Highland Hills Lot #40 5-10-93

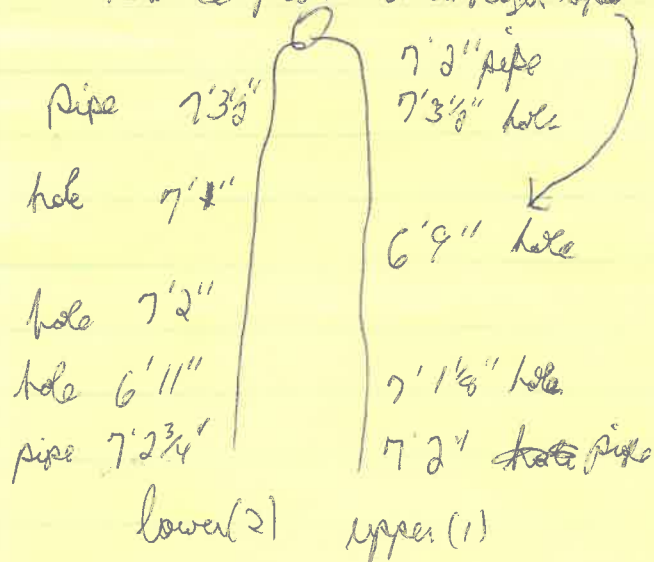
Reverse grade with high spot

D-box not level

- 1-3 inches of gravel under pipe
- not enough gravel in general
